Addendum 05

PROJECT: Fort Loramie Local Schools Athletic Complex Building & Associated Improvements
600 East Park Street
Fort Loramie, Ohio 45845

PROJECT #: 25041.00

This addendum form is a part of the Contract Documents and modifies the Bidding Documents dated December 11, 2025 with amendments and additions noted below.

SHEET NUMBER:
A0.2

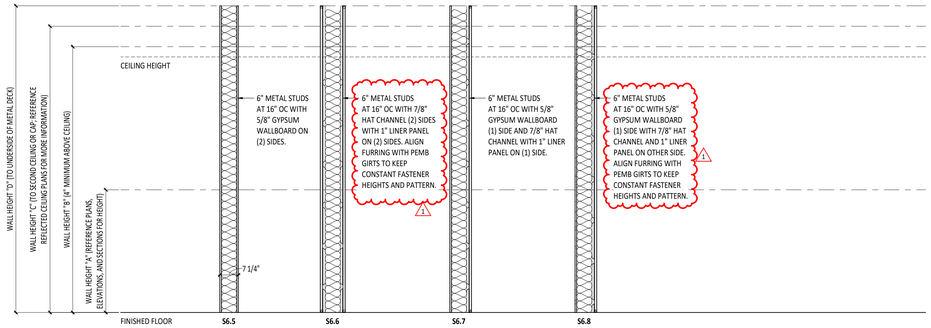
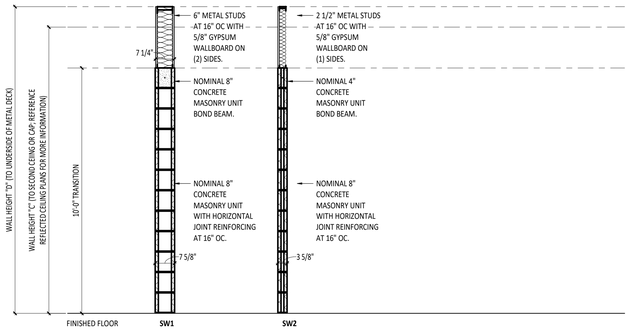
a. Alternate 07 site furnishing details have been added. Locations to be determined by owner.
3. Sheet A0.2 – Wall Types/Mounting Height
   a. Added furring to walls with liner panel and metal stud.

2 A4.3 **EXTERIOR WALL ASSEMBLY**
1 1/2" = 1'-0"

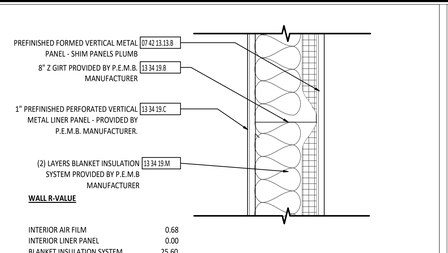
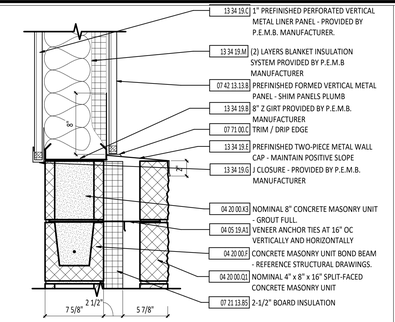
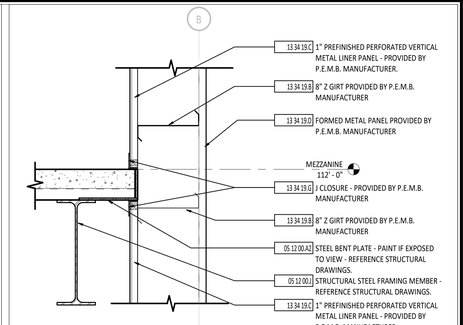
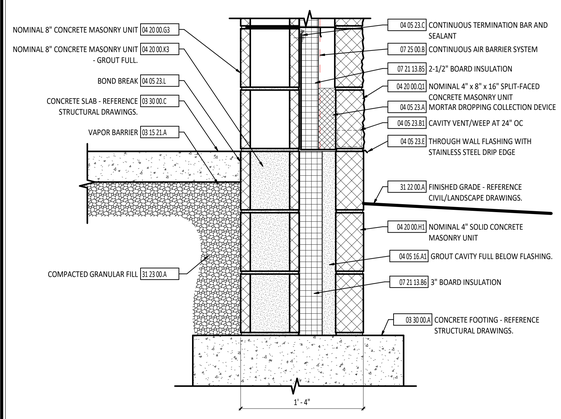
4. Sheet A4.3 – Section Details
   a. Added furring to walls with liner panel and metal stud.
5. Sheet A6.1 – Door Schedule and Details
   a. Added furring to walls with liner panel and metal stud.

1 A6.1 DOOR TYPES 1/4" = 1'-0"

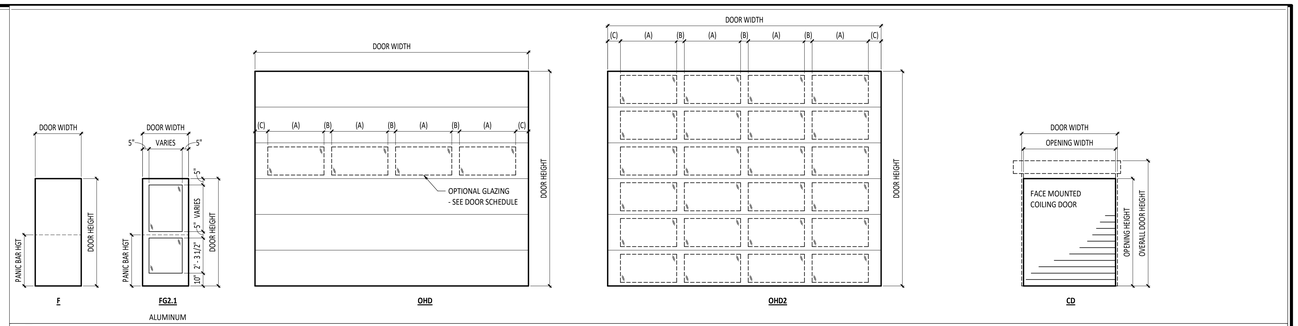
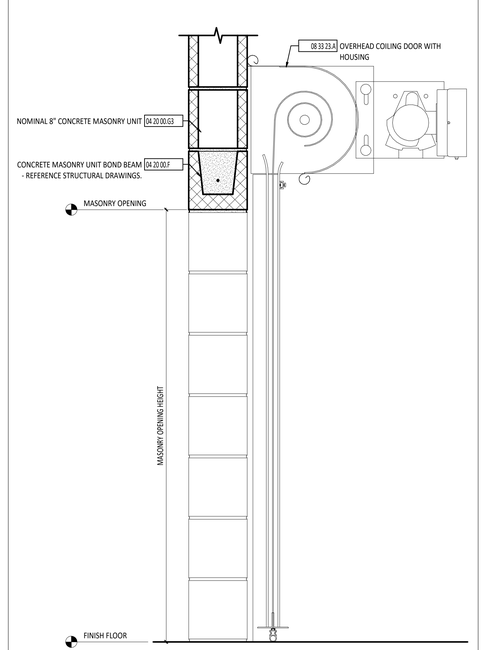
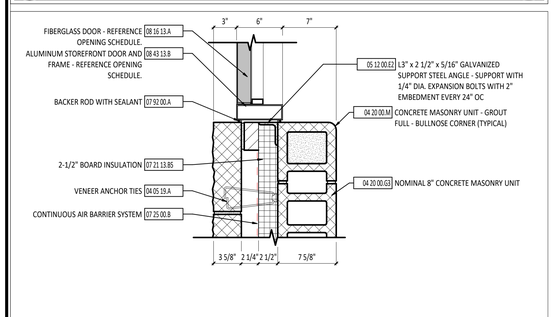
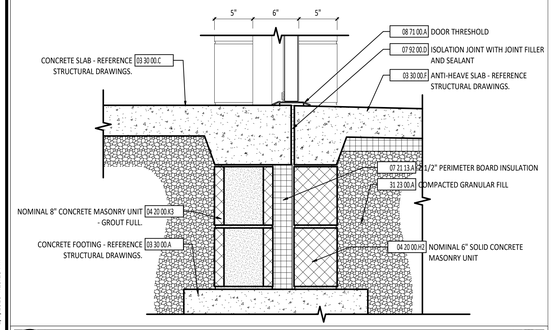
b. Revised Door Schedule A121 to reflect wheel chair lift modifications in Addendum 04. A121 is now a single door.
6. Sheet A6.2 – Storefront & Door Elevations/Details

1 A6.2 — STOREFRONT ELEVATIONS - EXTERIOR
1/4" = 1'-0"

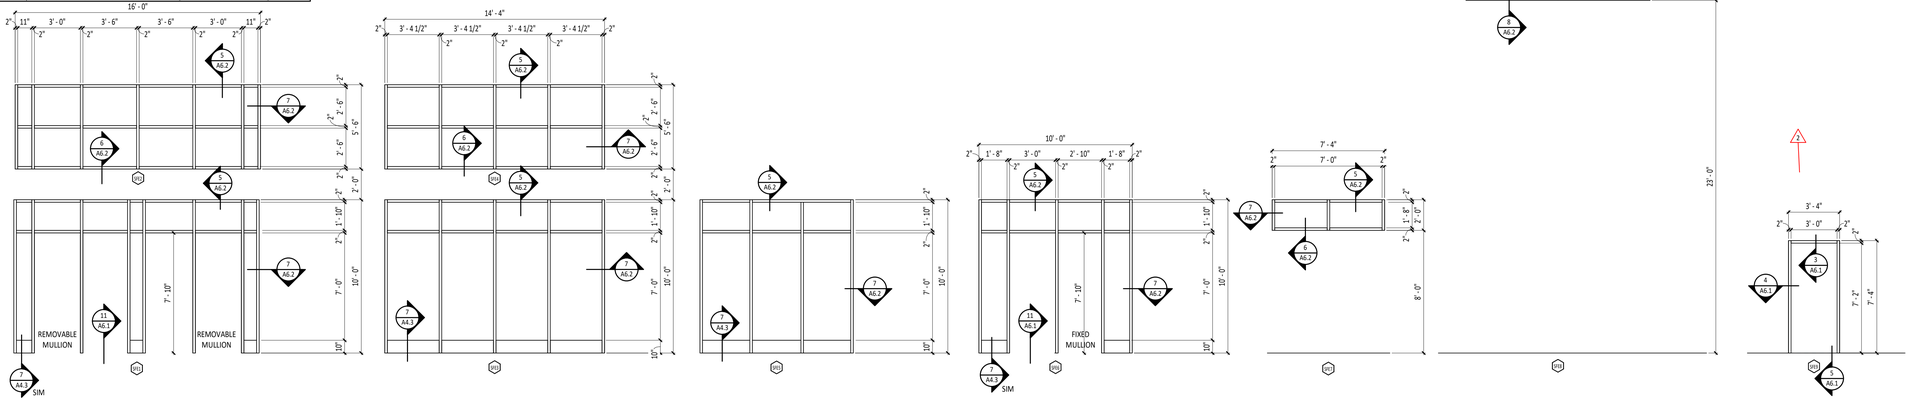
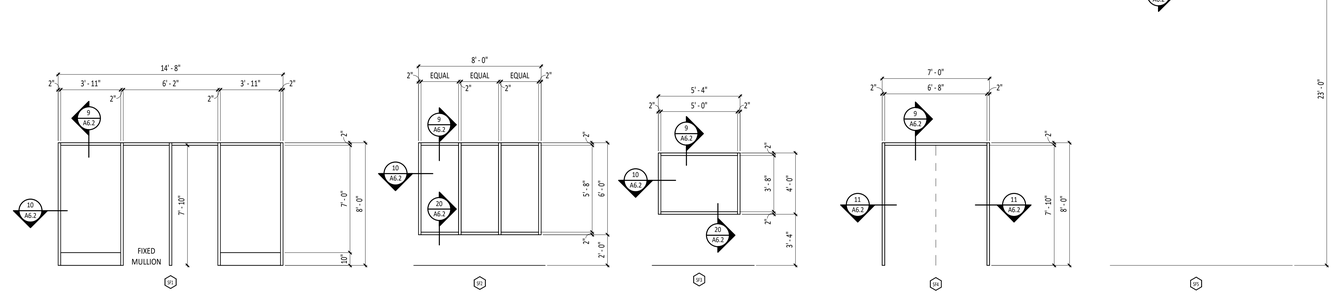
a. Added furring to walls with liner panel and metal stud.
7. Sheet A8.1 – First Floor Equipment Plan
   a. Remove metal shelving schedule
   b. Revised Equipment schedule to show E01 and E04 to be provided by contractor.

1 A8.1 **FIRST FLOOR EQUIPMENT PLAN**
1/8" = 1'-0"

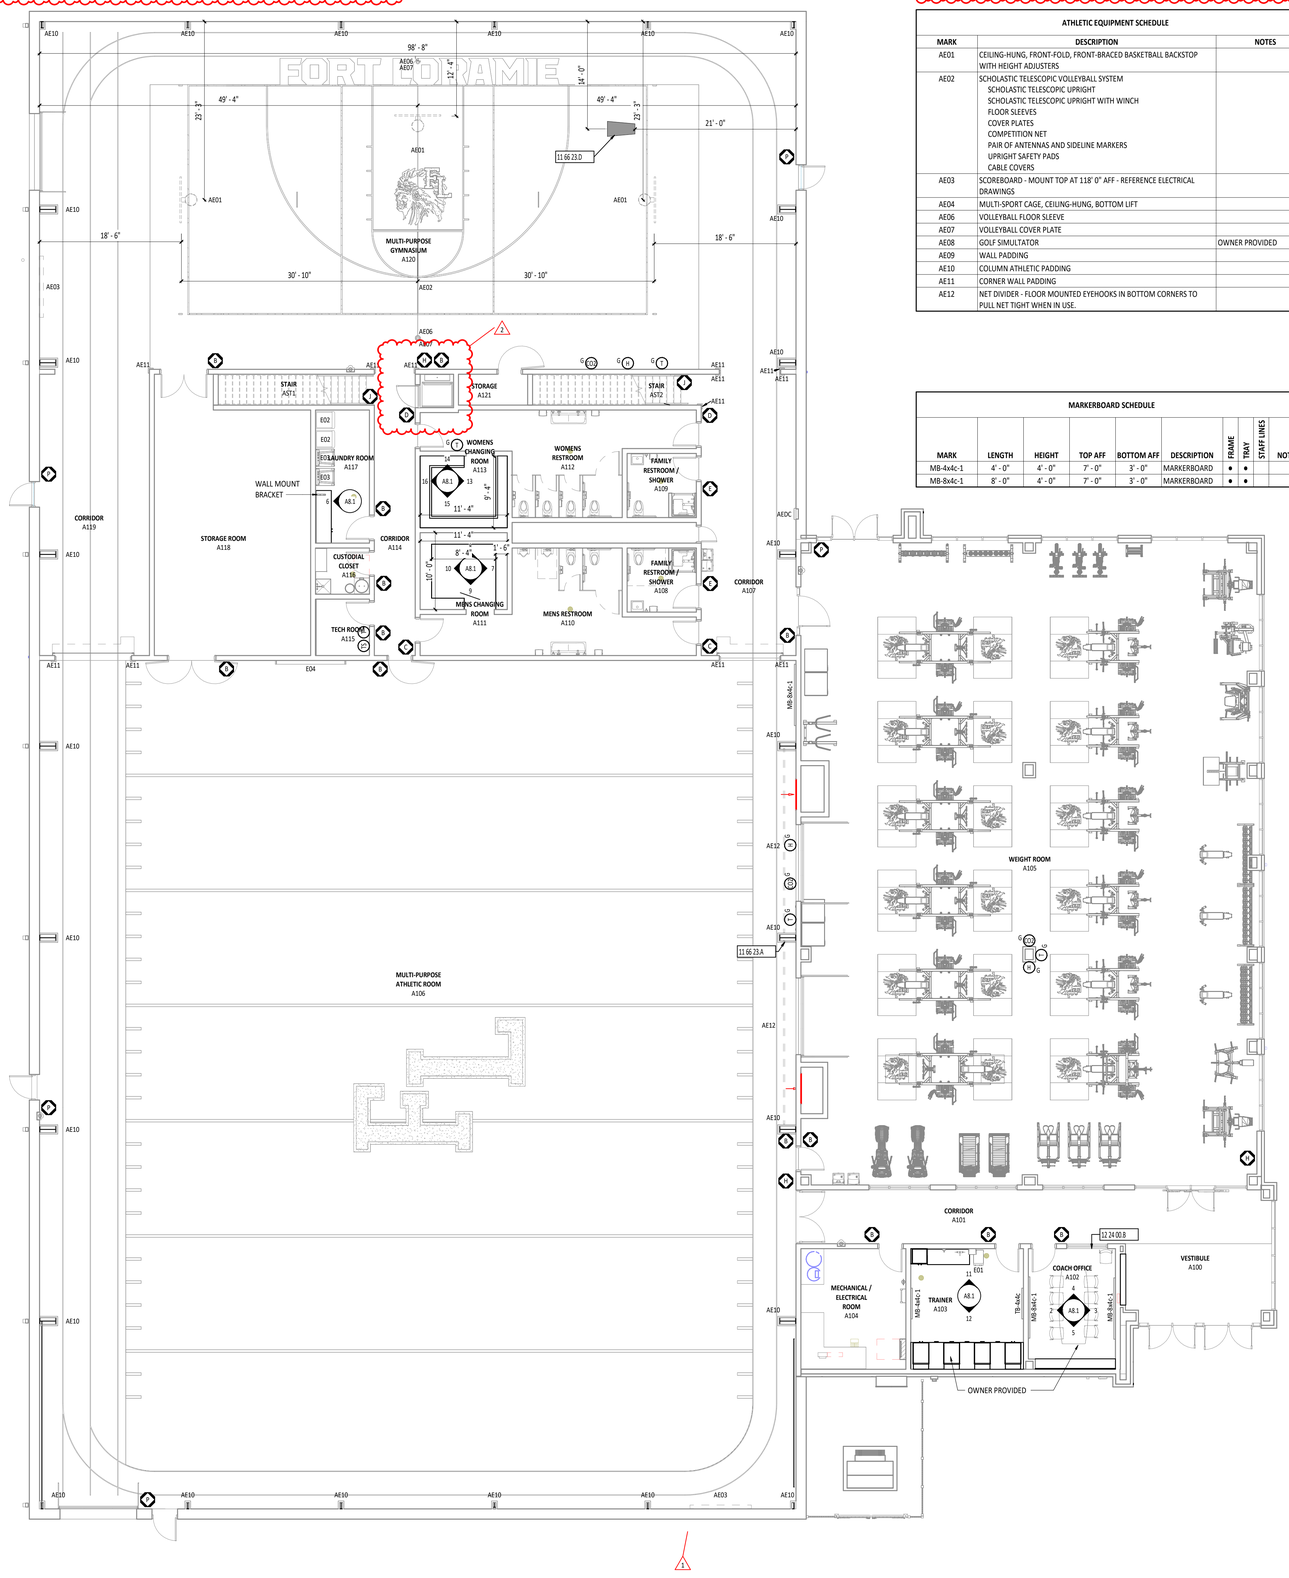
10. There is a Metal Shelving Schedule on A8.1 with M01 listed. There are no M01's shown on the drawings. Please Advise No metal shelving in project.
    a. **Response: Schedule removed from A8.1 in addendum 05**

11. Equipment Schedule on A8.1 does not designate whether the Cube Ice machine and the projection screen are to be provided by the owner or contractor. Please Advise.
    a. **Response: Both are provided by contractor**

10 E1.2 LIGHTING SEQUENCE OF OPERATIONS
NTS

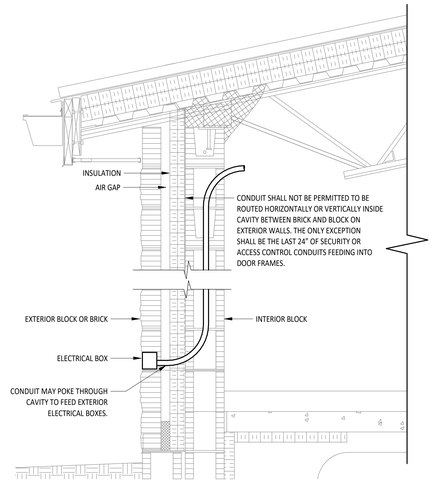
a. Added Detail 10 – Lighting Sequence of Operations
    b. Removed Dead Front GFCI detail (no longer applicable).
    c. Removed nLight lighting control detail (no longer applicable).

1 E2.1 **SITE ELECTRICAL PLAN**
1" = 20'-0"

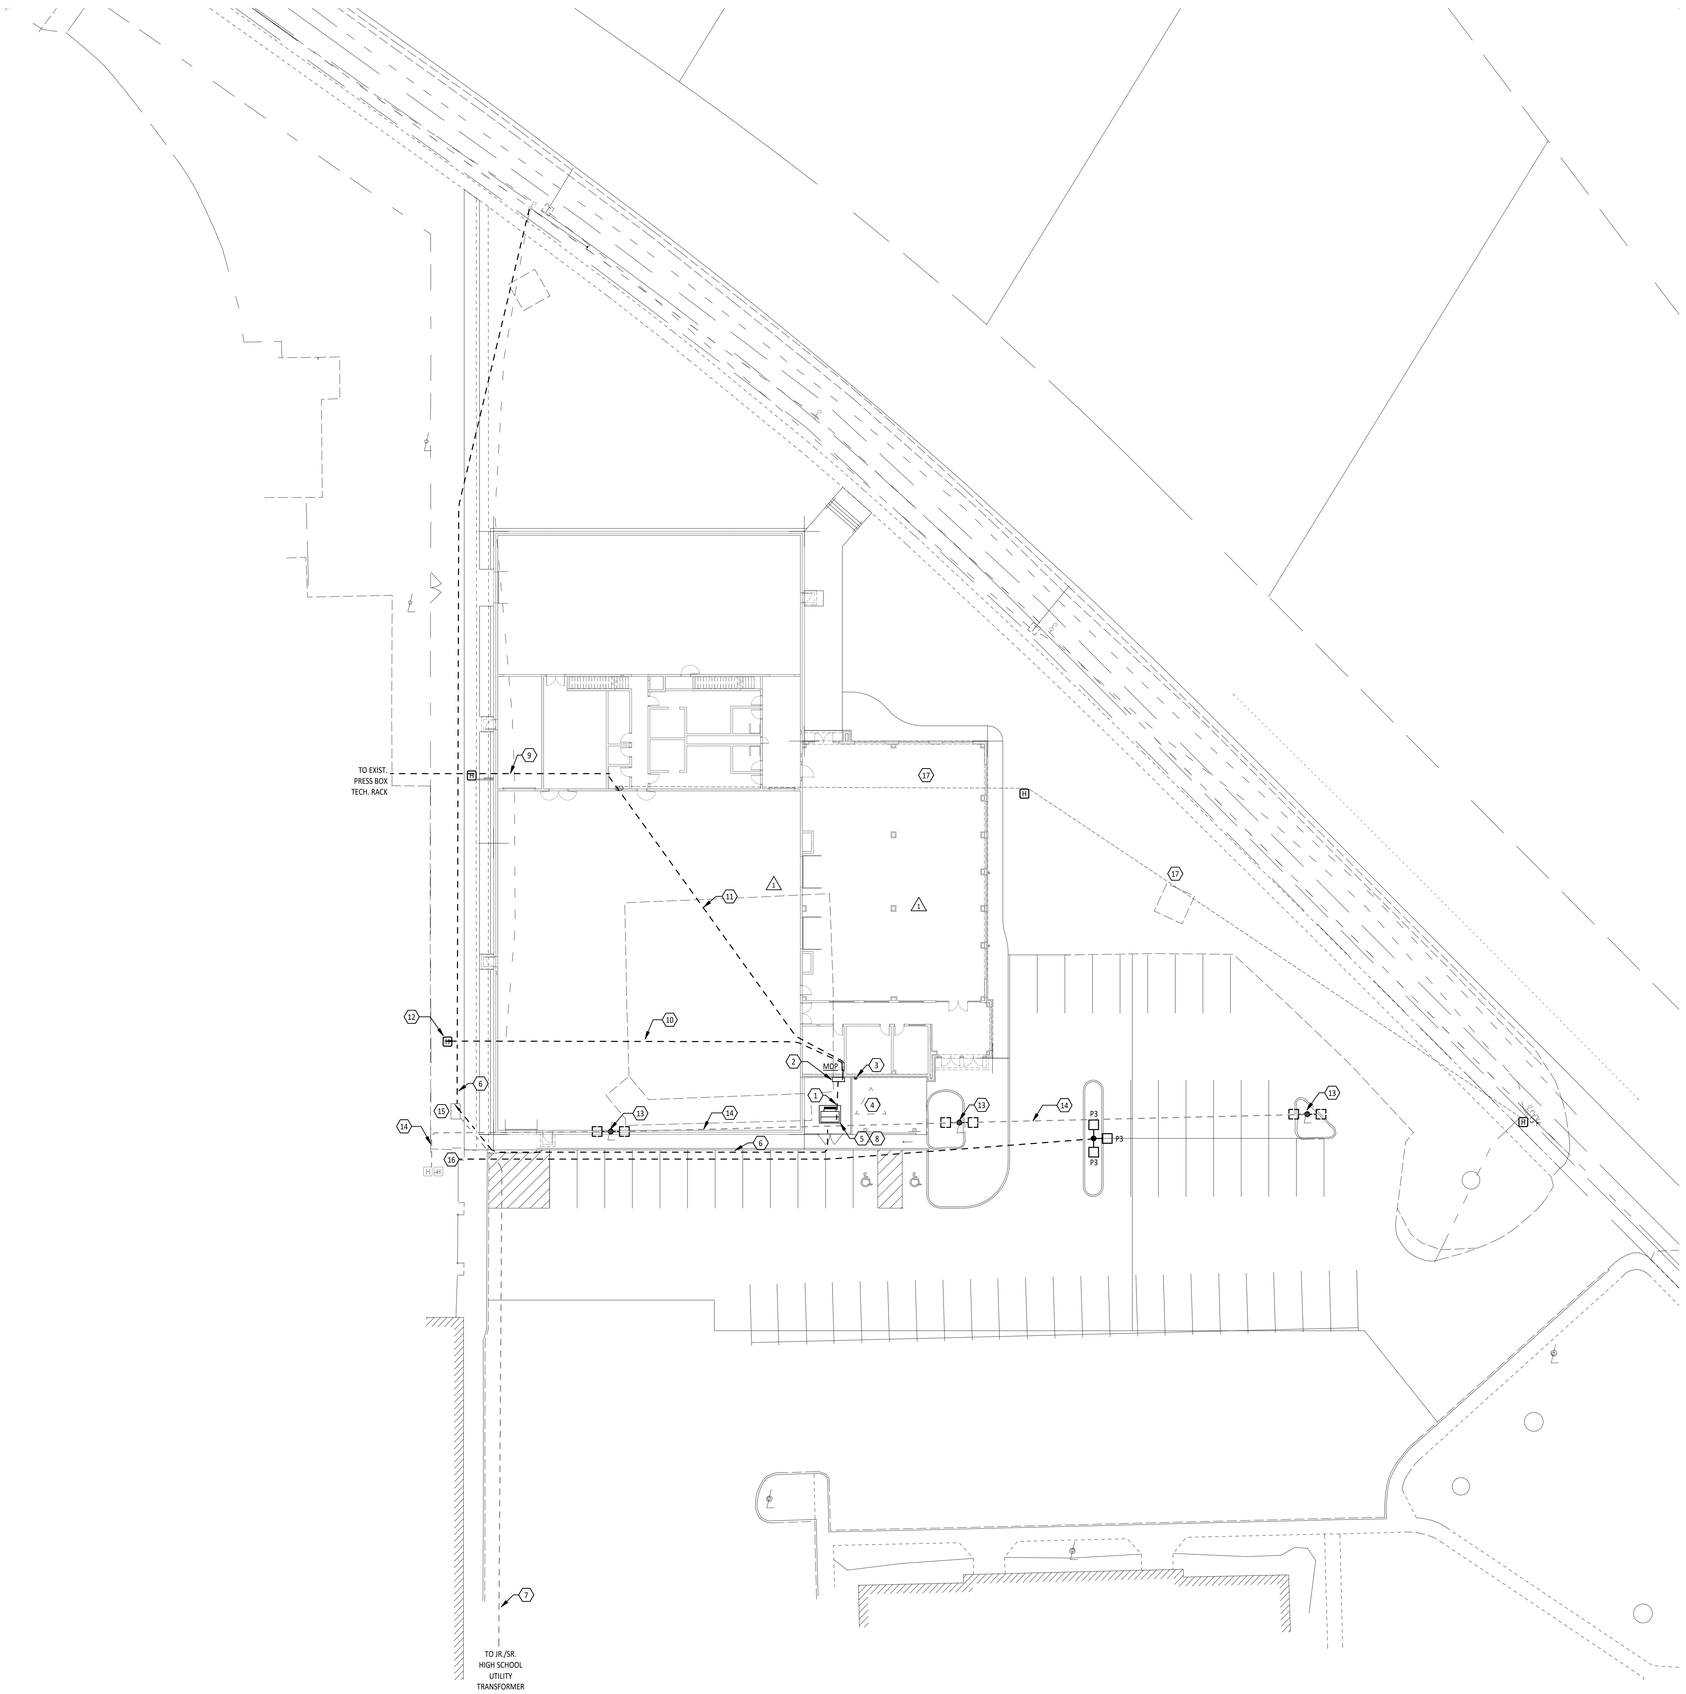
d. Removed access control system schematic wire diagram (already on T series sheet).
14. Sheet E2.1 – Site Electrical Plan
    a. Keynote 11 – Adjusted grounding size to technology room.

1 E3.1 **FIRST FLOOR SYSTEMS PLAN**
1/8" = 1'-0"

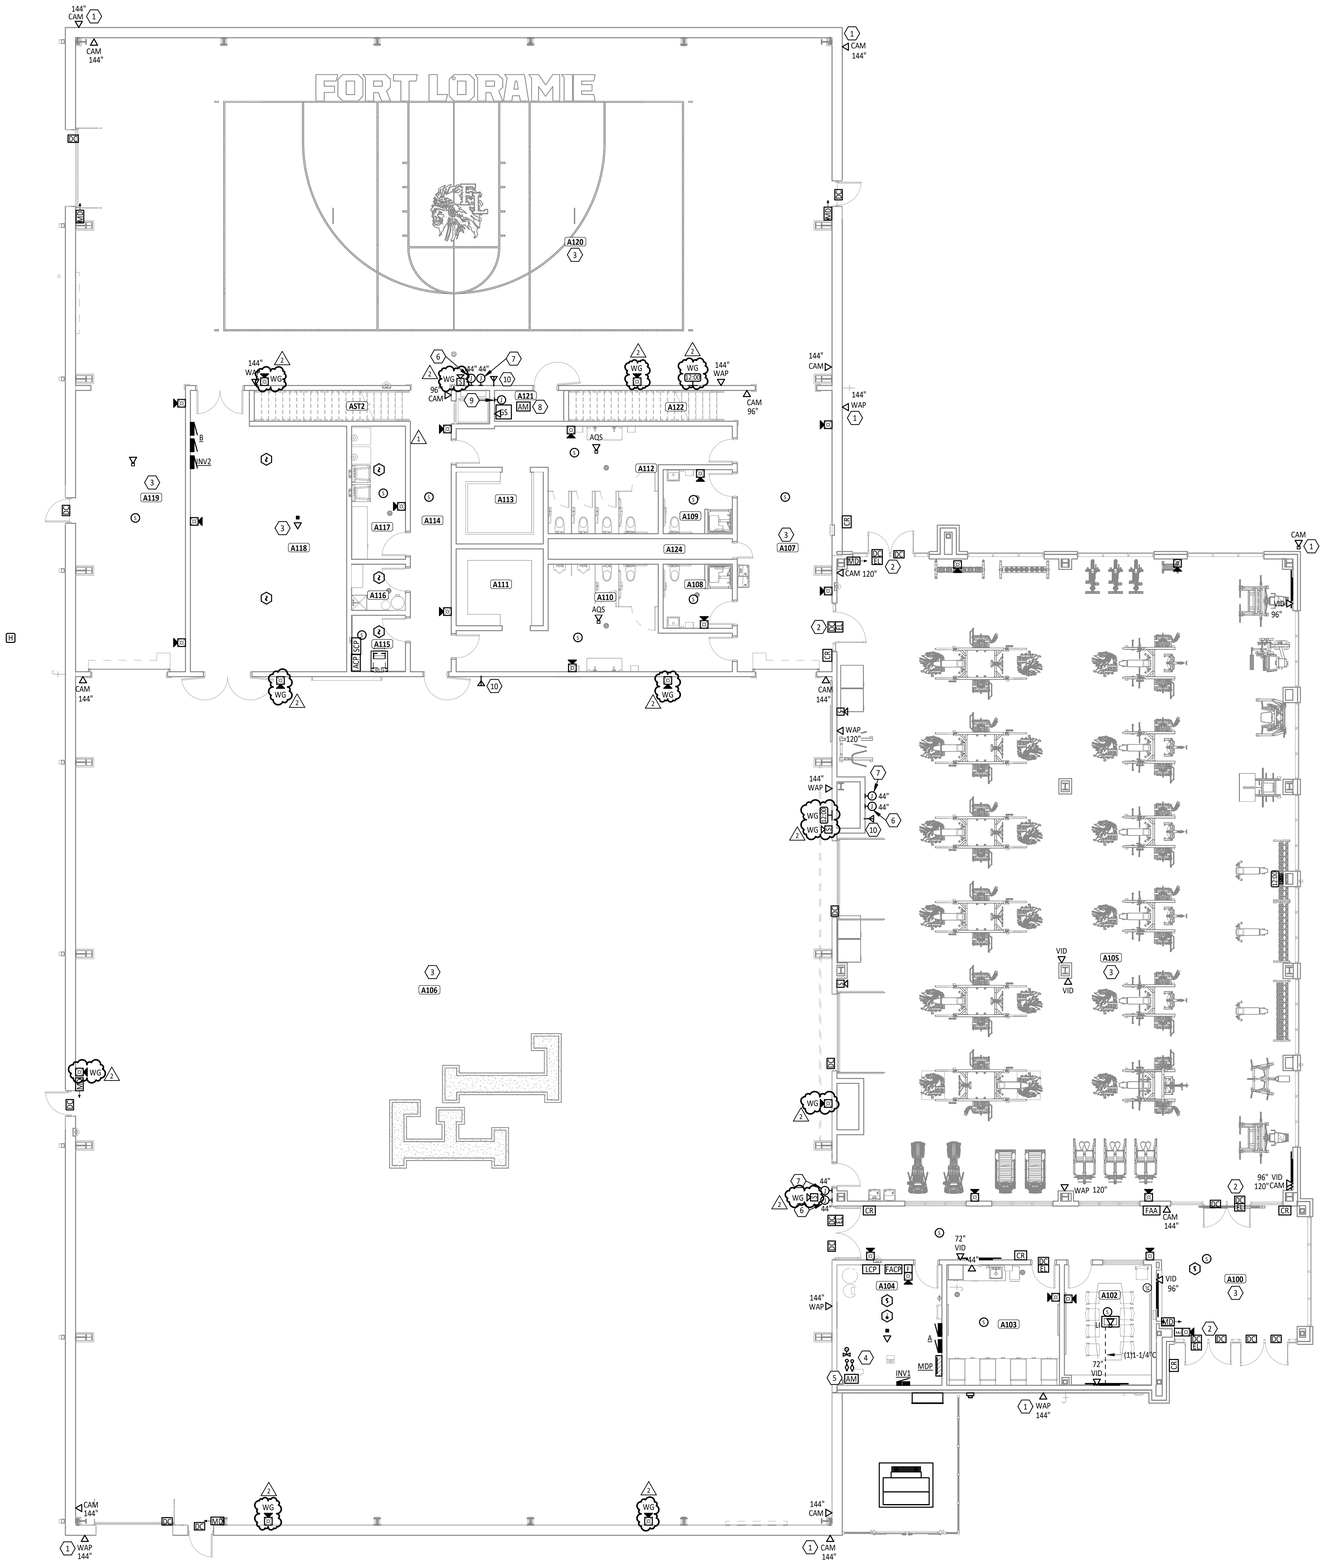
15. Sheet E3.1 – First Floor Systems Plan
    a. Provided wire guard for fire alarm devices, clocks, and speakers in A106.
    b. Provided wire guard for fire alarm devices, clocks, and speakers in A120.
